SLAA Technical Consultation

Site Ref: HatfieldBO 005 MIX

Unsustainable Sites Action Group

Hatfield Broad Oak Parish Council

The CLN 22 Departure route for Stansted
(Immediately over the garden community site, all below 3,000 ft)
DfT/CAA guidance says that aircraft noise reduction is a priority up to 7,000ft

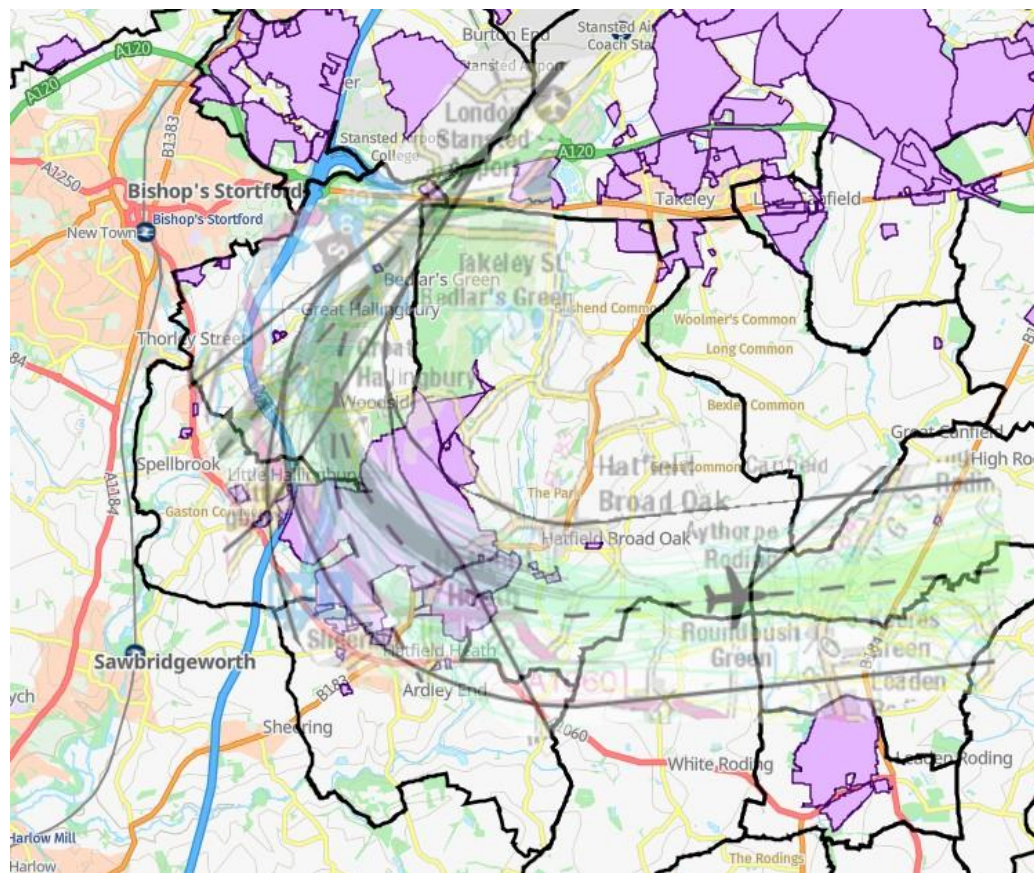
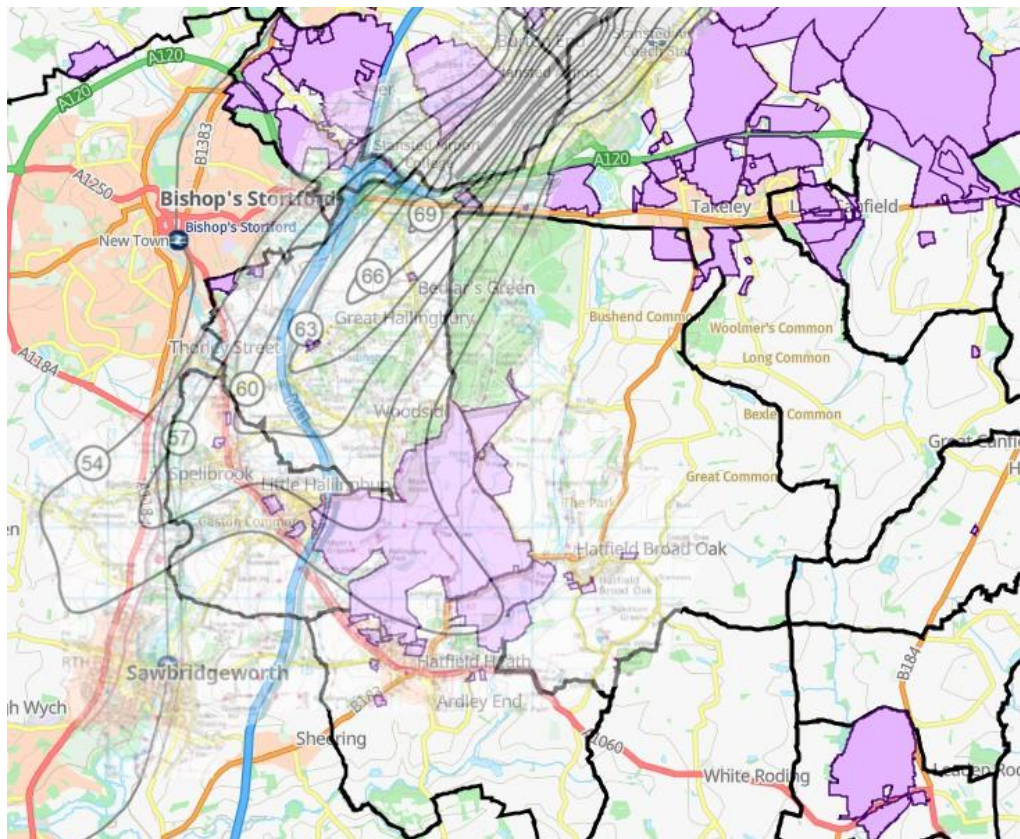
Much of the site would be at a higher noise event level and these contours should be established. These are actual events rather than 16-hour averages. This alone makes the garden community site not only unsustainable but unbearable place to live with considerable health and wellbeing impacts.

The 2019 54 dB daytime noise contour

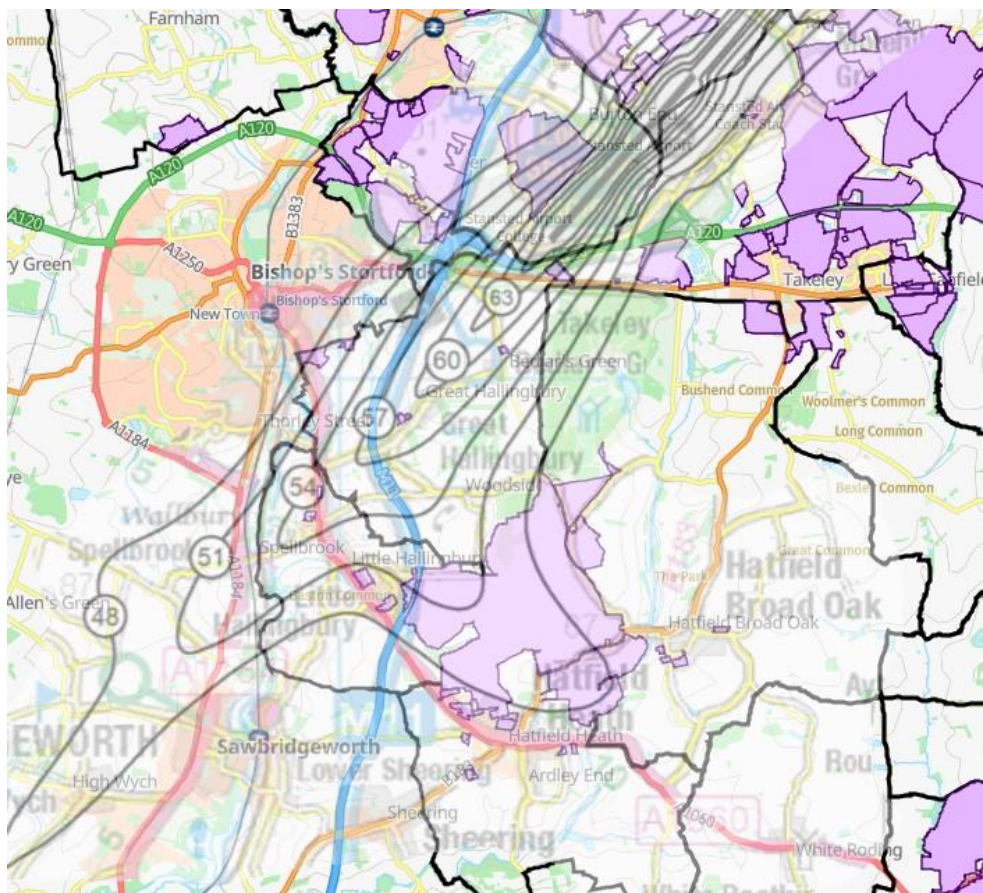
The 2019-night noise contours showing the entire site well within the 48 dB contour and above the WHO guidelines

With expansion of Stansted now granted, the inquiry was evidenced with projected noise contours for 2032.
Clearly all of the garden community site falls within the 51dB contour

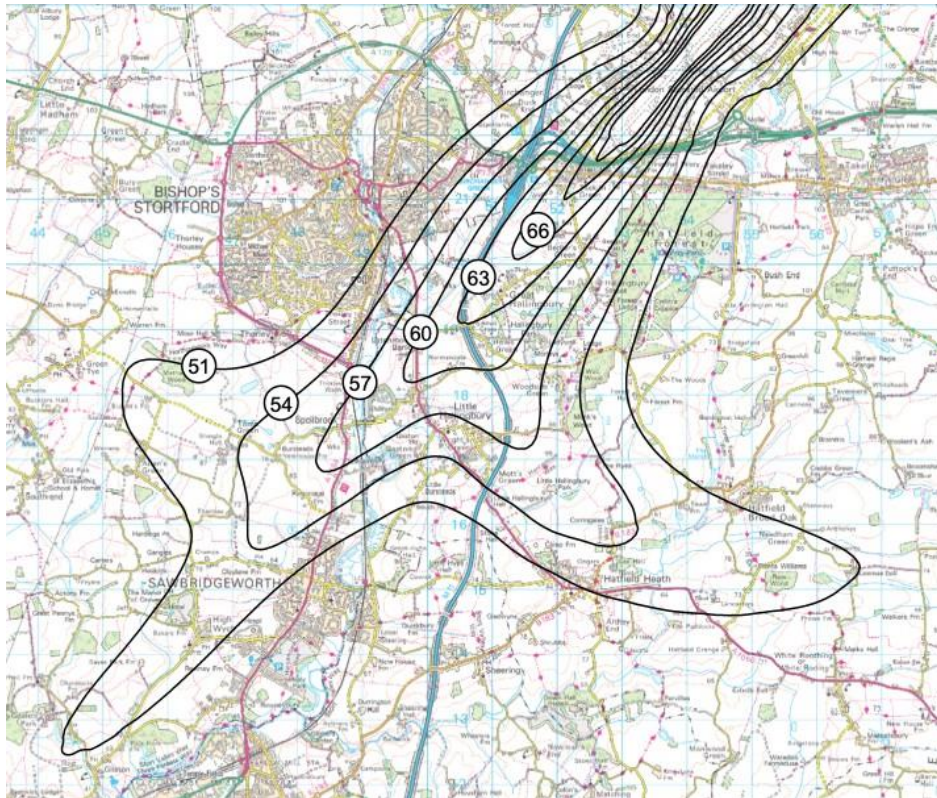
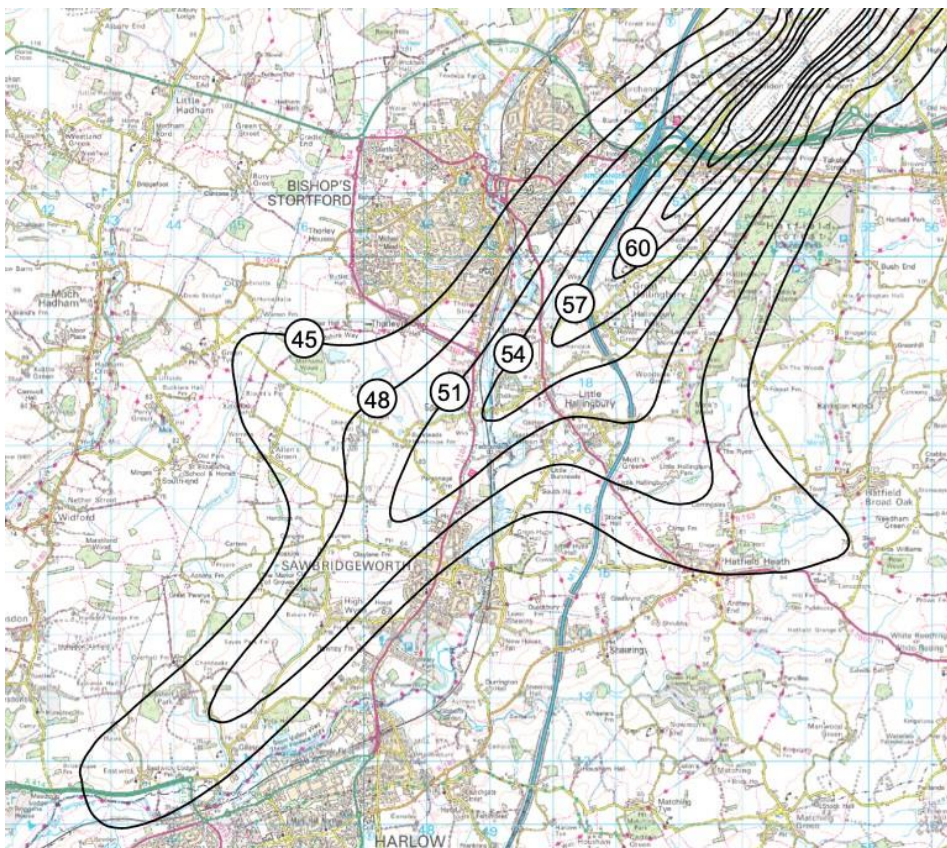
The entire site falls within the 45 LAeq contour
in excess of the night-time limits recommended by WHO.

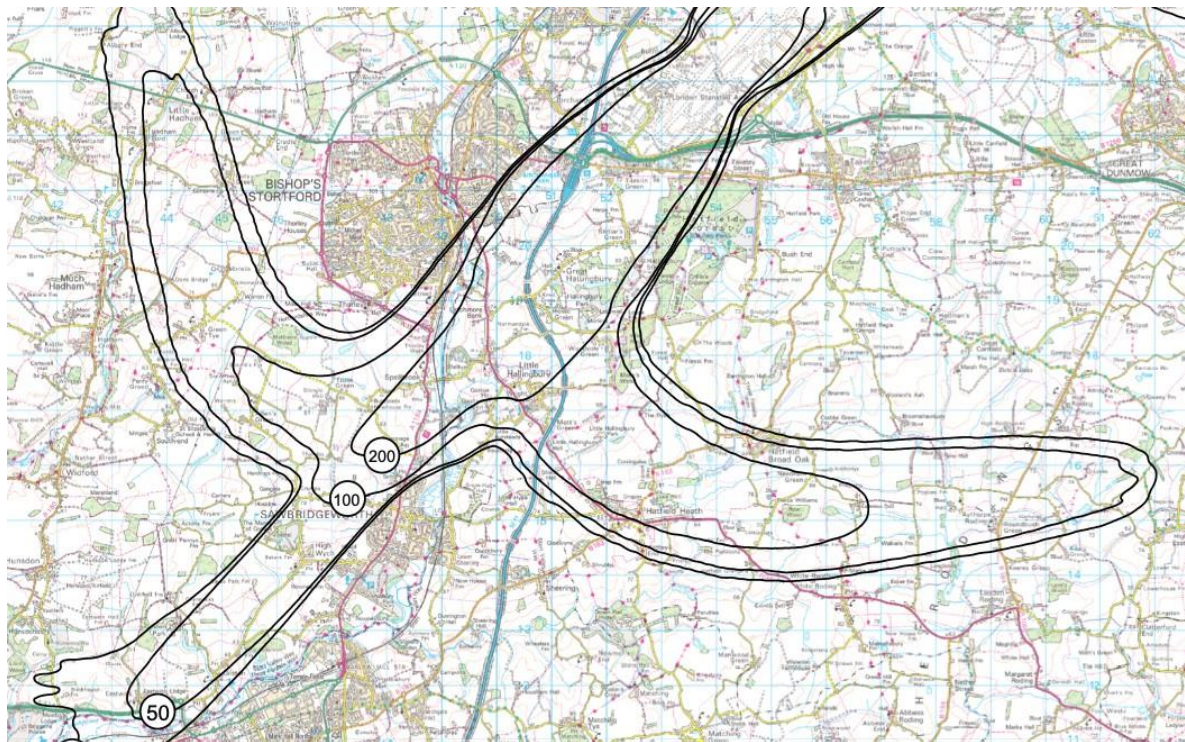
When using the more respected 'N' contours (numbers above), denoting the number of events above a defined noise threshold, it can be seen there would be between 100 and 200 noise events per day of 65db over the garden community site.
